ECE/TRANS/WP.30/GE.1/2007/15  
22 October 2007

Образец данных Всемирной таможенной организации о транзите

Записка секретариата\*

**WCO/DMPT – TIR DMRs**

<b>WCO LOG:</b>	
<b>DATE:</b>	
<b>User reference (*):</b>	TRT_0004
<b>User date:</b>	19.06.2007

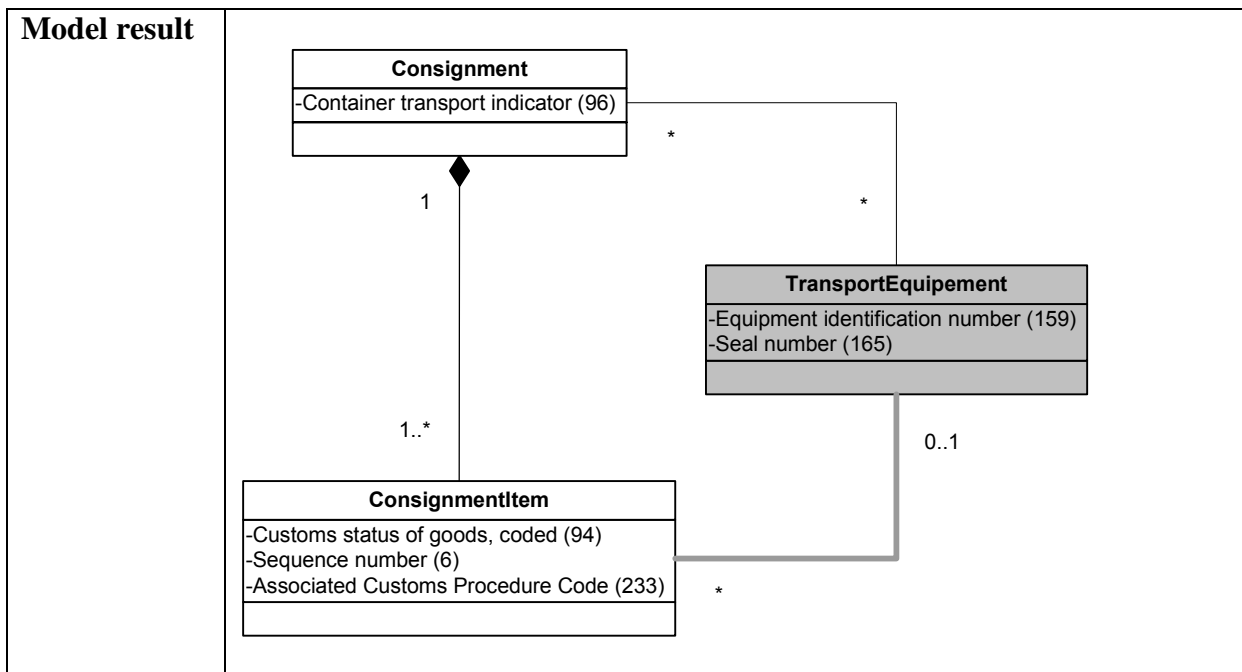
<b>Originator (*):</b>	DMPT_TRT
<b>Contact person (*):</b>	André Sceia
<b>Email (*):</b>	andre.sceia@unece.org
<b>Phone (*):</b>	+41 22 917 13 13
<b>Data set (*):</b>	TRT
<b>Attached Documentation</b>	-
<b>Business Need/Justification (*):</b>	In the WCO data model, the <b>TransportEquipment</b> class is linked to the Consignment, whereas the EquipementIdentification, containing only the ID of the Transport equipment, is linked to the ConsignmentItem class. It is an accepted practice in modelling that the identifier of a class is an element of the class and not stored in another class.

<b>User reference (*):</b>	TRT_0004
<b>MIG/Model Tag (*):</b>	TRT
<b>Name of MIG/Model (*):</b>	Transit
<b>Action (*):</b>	The transit subgroup proposes to remove the EquipmentIdentification class and have the data element 159 (Equipment identification number) moved to the Transportequipment class. This class would be linked to both Consignment and ConsignmentItem classes.
<b>Terms and Definitions</b>	-

<b>Oper</b>	<b>Posn (*)</b>	<b>Seg (*)/ DE (*)</b>	<b>Segment/ Data element Name (*)</b>	<b>Stat (*)</b>	<b>Rpt (*)</b>	<b>Lvl (*)</b>	<b>Sect</b>
X	-	159	Equipment identification number	C	1	-	-
<b>Explanatory Text</b>		Remove the DE 159.					
X	-	-	EquipmentIdentification class	-	-	-	-
<b>Explanatory Text</b>		Remove the EquipmentIdentification class.					
A	-	159	Equipment identification number	-	-	-	-
<b>Explanatory Text</b>		Add D.E. 159 to the Transportequipment class.					
A	-	-	Relationship	-	0:1 0:n	-	-
<b>Explanatory Text</b>		Add a relationship between the Transportequipment class and the ConsignmentItem class.
